ATS & PSFP YANG maintenance items #0392 & #0393 ver 3.1

Maintenance items

- ATS schedulers and scheduler-groups YANG containers don't align with 802.1Q-2022
- Multiple Scheduler Instance Tables and Scheduler Group Instance Tables are created in a bridge components

- Need a clarification of using stream-filter when a bridge uses both ATS and PSFP

Figure 48-16—Asynchronous Traffic Shaping model

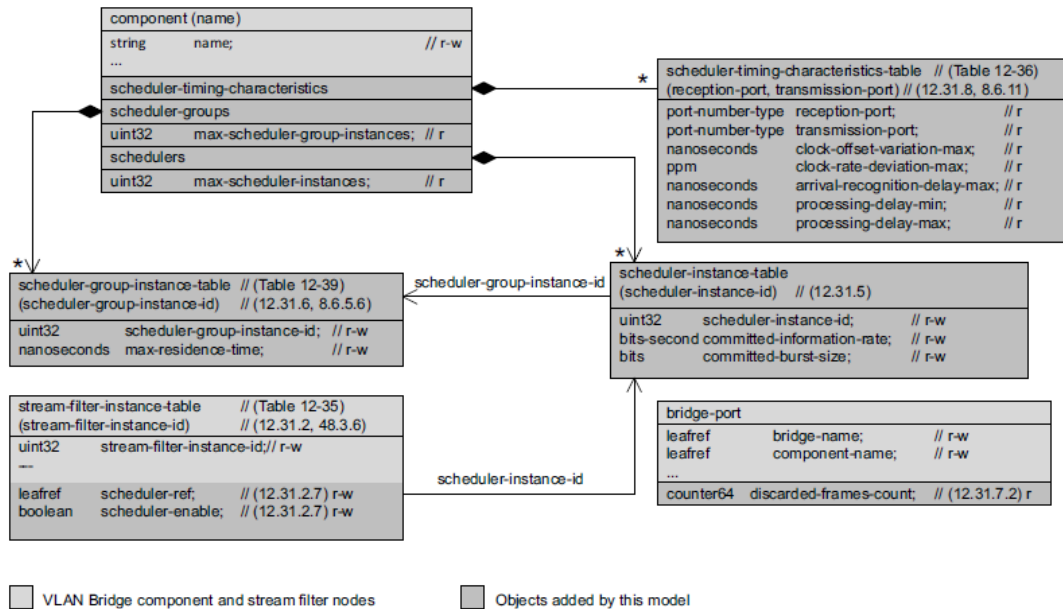
- a) The Scheduler Instance Table (12.31.5)
- b) The Scheduler Group Instance Table (12.31.6)
- c) The Scheduler Port Parameter Table (12.31.7)
- d) The Scheduler Timing Characteristics Table (12.31.8)
- e) A Stream Filter specification type representing an ATS scheduler instance identifier (12.31.2.5)

- **Current ieee802-dot1q-ats-bridge.yang**
 - *ats:ats-parameters* is under augment of “stream-filters/stream-filter-instance-table”
 - It creates multiple ***the Scheduler Instance Table (12.31.5)*** and ***the Scheduler Group Instance Table (12.31.6)*** under ***the Stream Filter Instance Table (12.31.2)*** than one per the Bridge Component.

- No change needed on `ieee802-dot1q-ats.yang`
- Modified `ieee802-dot1q-ats-bridge.yang`
 - Move `ats:ats-parameters` out of augment of “stream-filters/stream-filter-instance-table”
 - It creates *single Scheduler Instance Table (12.31.5)* and *single Scheduler Group Instance Table (12.31.6)* under the Bridge Component.

Figure 8-13—Flow classification and metering

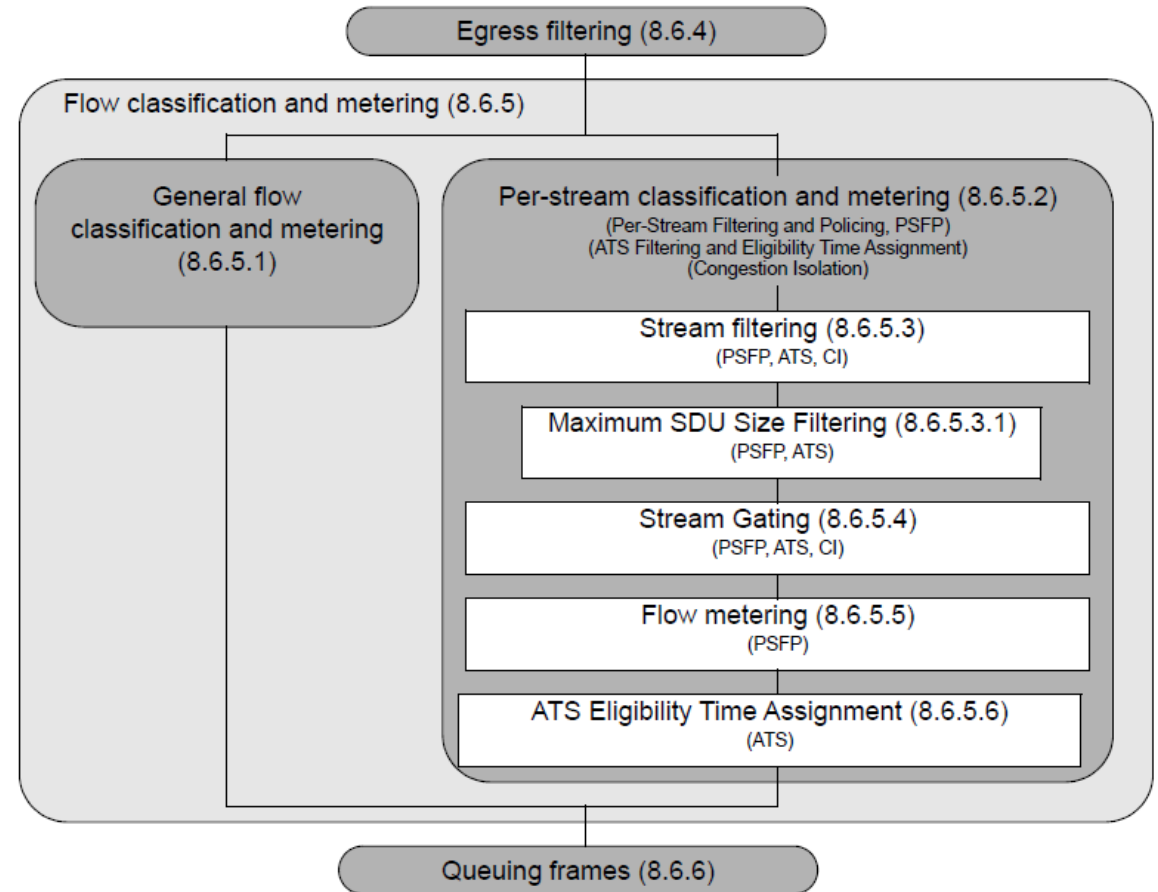
- **8.6.5 states**
 - “PSFP and ATS share common per-stream classification and metering elements, as shown in Figure 8-13.”
- **8.6.5.2 d) states**
 - “... A given stream filter can be configured with flow meters and an ATS scheduler if both PSFP and ATS are supported.”
- **8.6.5.2.2 b) states**
 - “If the Bridge component does not support PSFP in addition to ATS, each stream gate only supports IPV assignment. ...”
 - NOTE 2—For bridges with support for ATS, and without support for PSFP, stream gates of ATS traffic will never close. In this case, stream gates are only used for IPV assignment.

sfsg:sfsg-parameters reference analysis

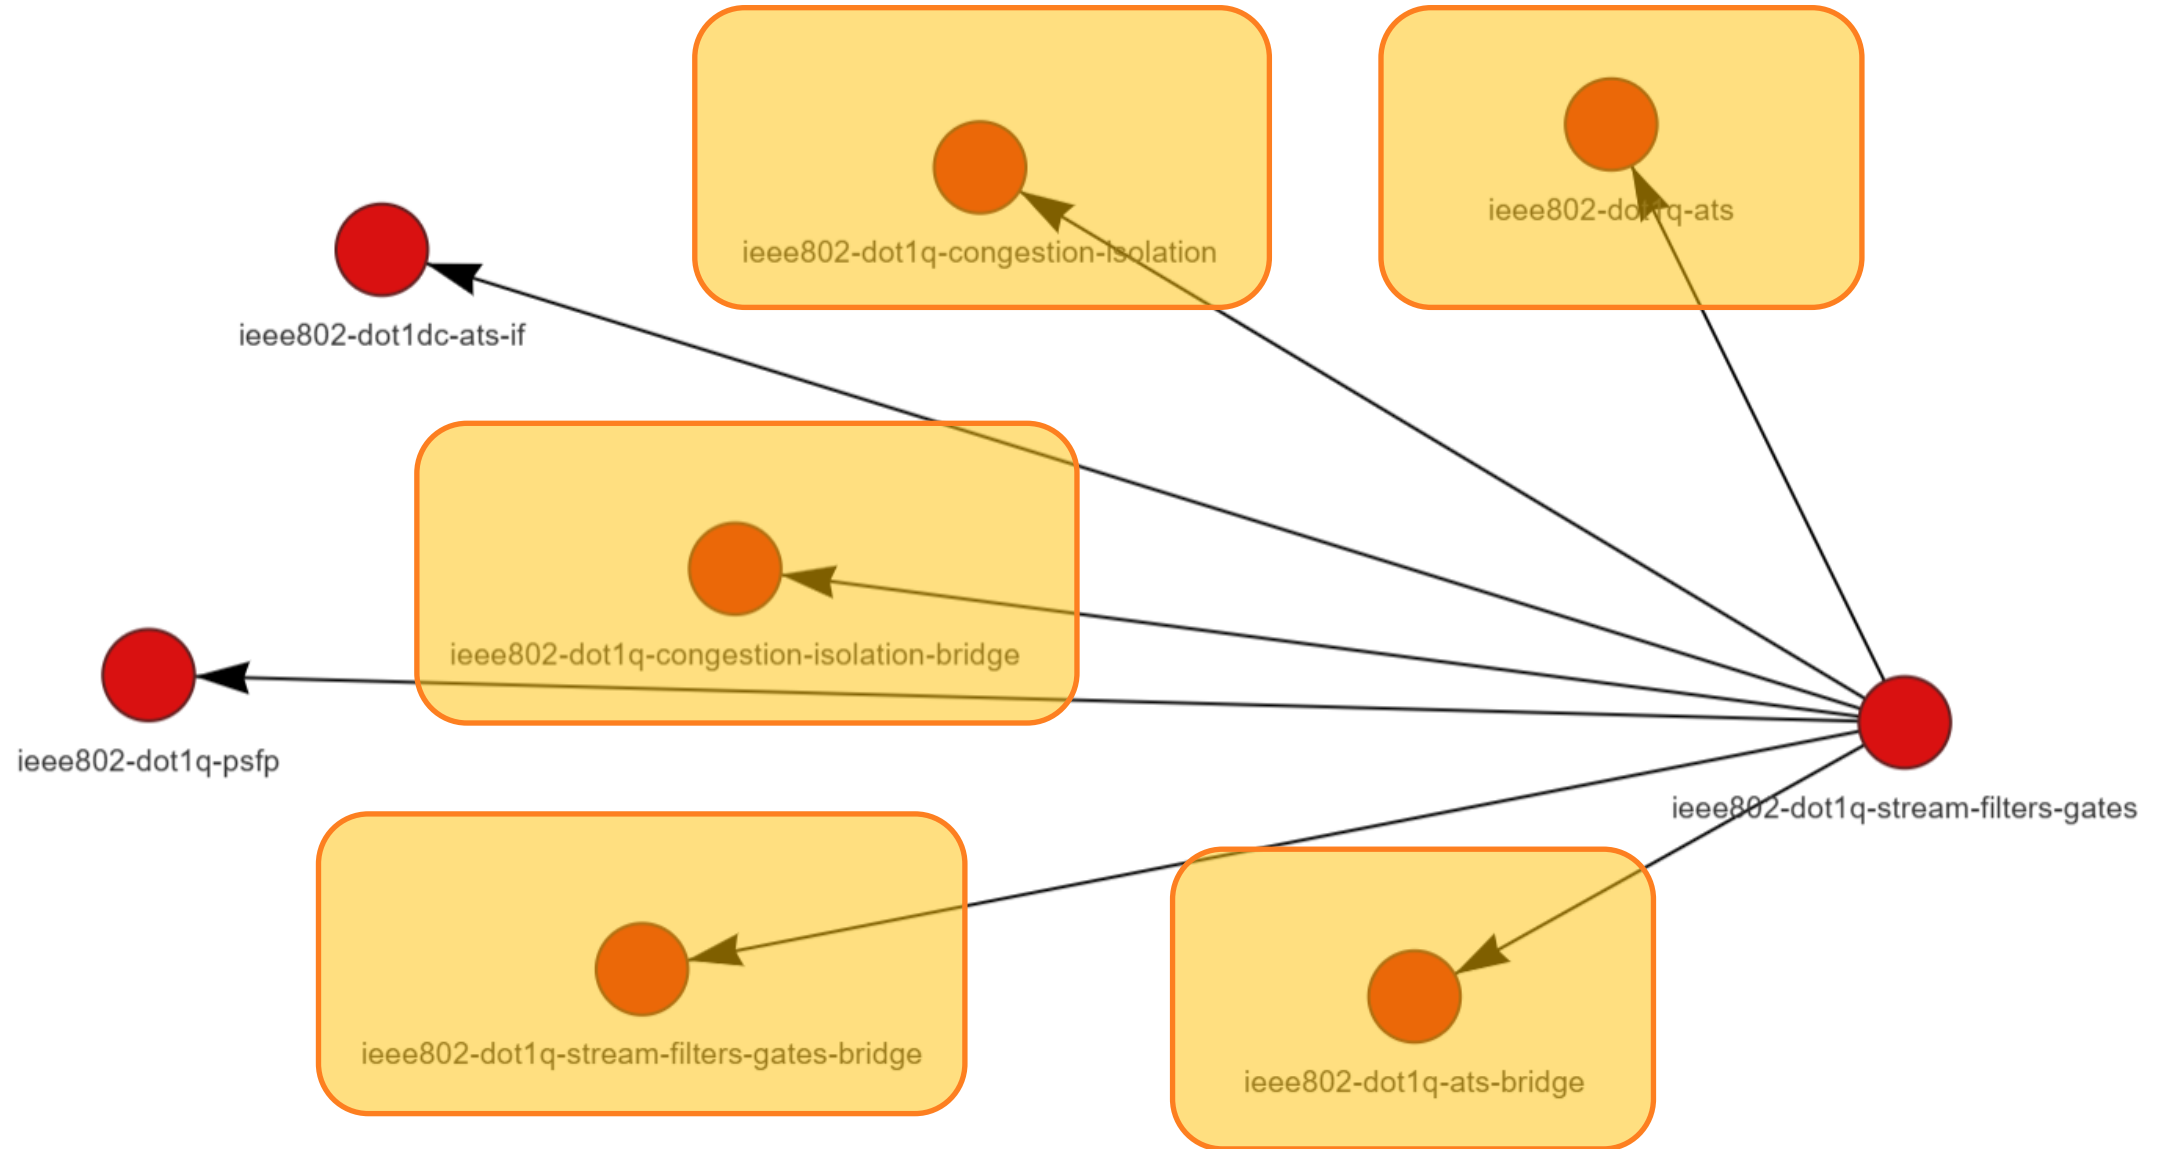
- **Current implementation**
 - Define “*grouping sfsg-parameters*” in ieee802-dot1q-stream-filters-gates.yang
 - Uses “*uses sfsg:sfsg-parameters*” in 3 modules of ieee802-dot1q-[ats/psfp/congestion-isolation]-bridge.yang
- **Problem**
 - “*Uses*” statement copies the nodes defined by the “*grouping*” into the current schema tree.
 - This creates **own Stream Filter and Stream Gate of each module** under the bridge component.

- **Removing “use sfsg:sfsg-parameters” in**
 - ...ats-bridge.yang, ...psfp-bridge.yang (i.e., ...pspf.yang) and ...congestion-isolation-bridge (i.e., ..congestion-isolation.yang)
 - ...ats-if.yang, & ...psfp-sys.yang
- **Use a base modules**
 - ieee802-dot1q-streams-filters-gates-bridges.yang for bridge functions
 - for bridge (802.1Q) : sfsg-bridge
 - ieee802-dot1dc-streams-filters-gates-sys.yang for system functions
 - for system (802.1DC) : sfsg-sys
- **Each module augment into base node created by base modules**
 - sfsg-bridge
 - ats-bridge
 - psfp-bridge
 - ci-bridge

sfsg:sfsg-parameters reference analysis

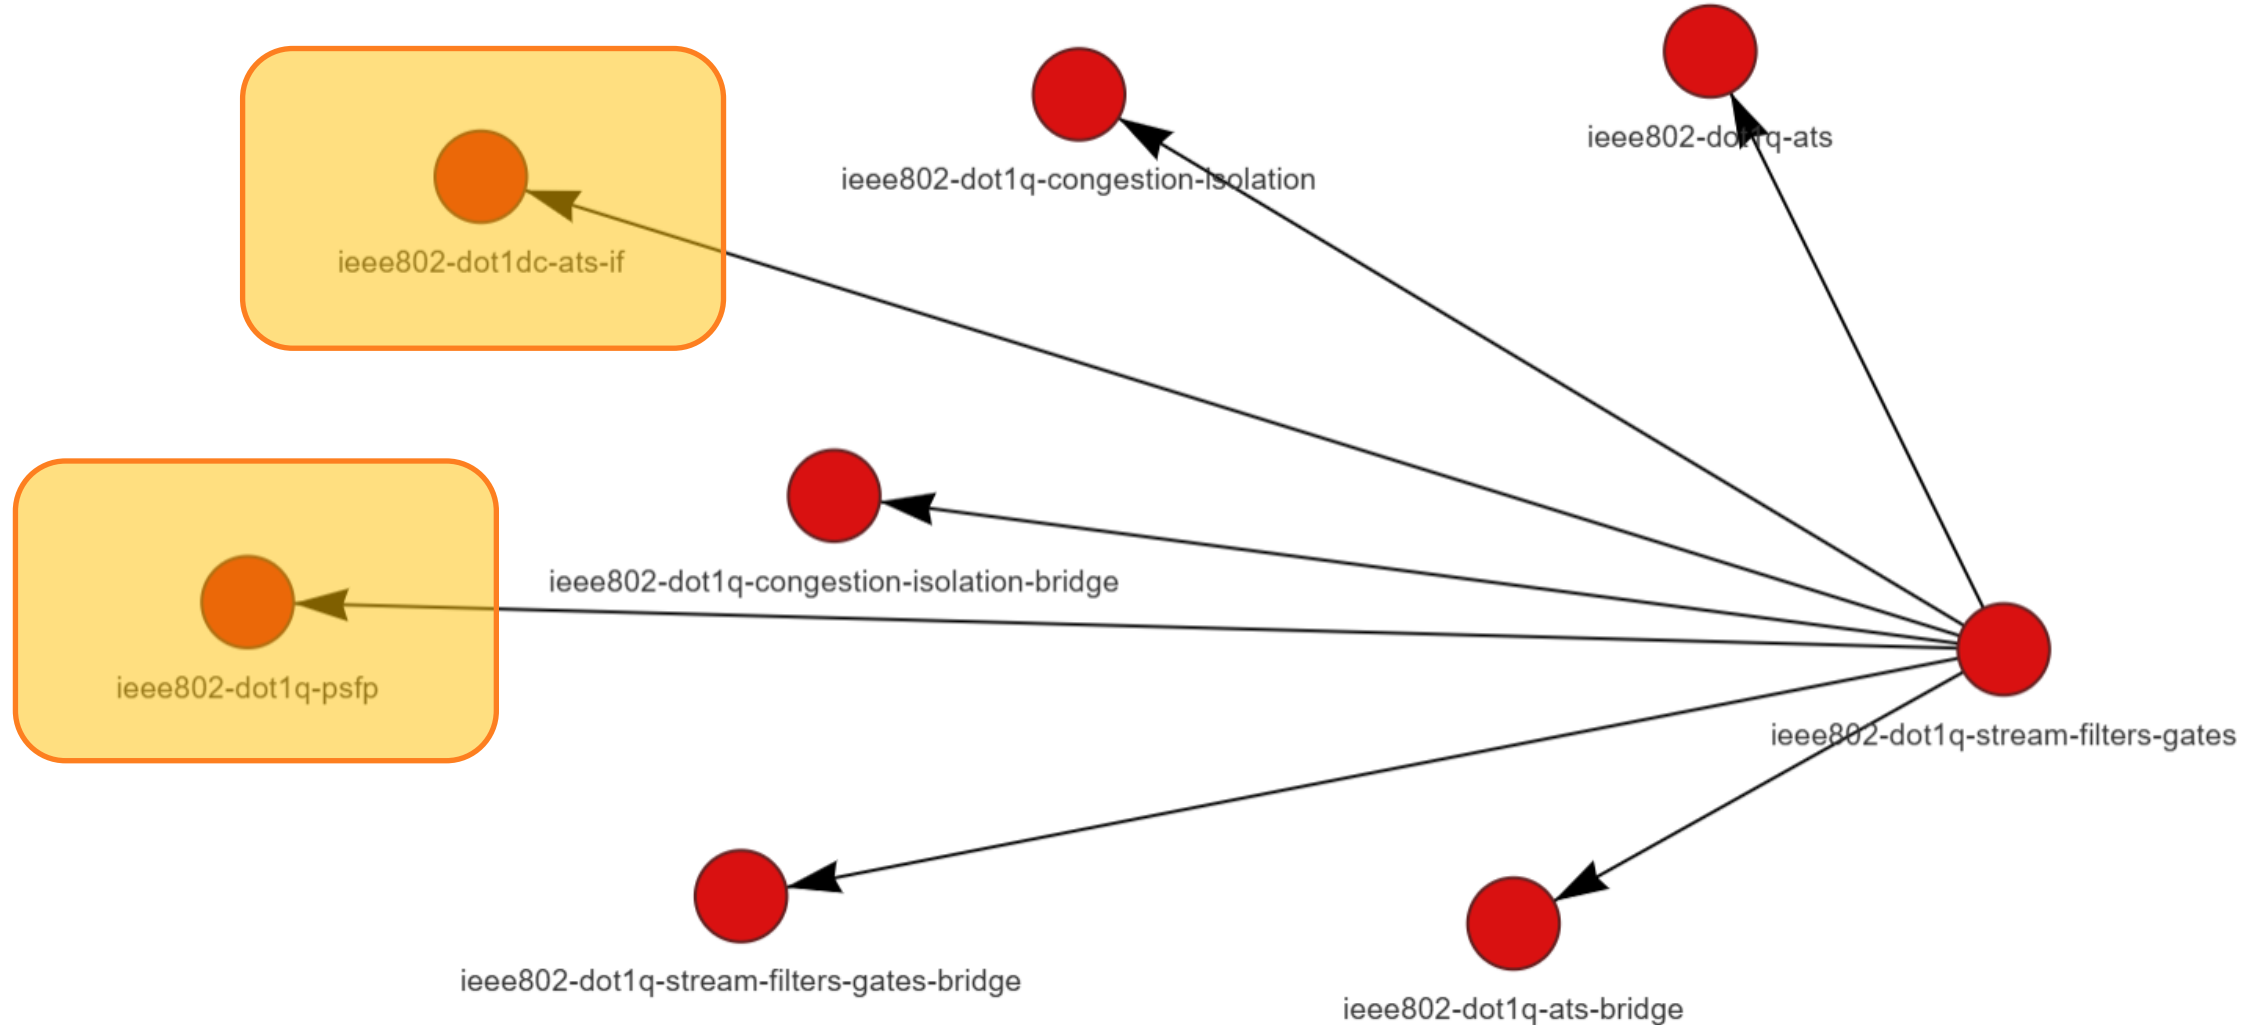
- Define “*grouping sfsg-parameters*” in ieee802-dot1q-stream-filters-gates.yang
- Uses “*uses sfsg:sfsg-parameters*” in ieee802-dot1dc-psfp-sys.yang (from ieee802-dot1q-psfp.yang) and ieee802-dot1dc-ats-if.yang

- “*Uses*” statement copies the nodes defined by the “*grouping*” into the current schema tree.
- This creates **own Stream Filter and Stream Gate of each module** under the bridge component.
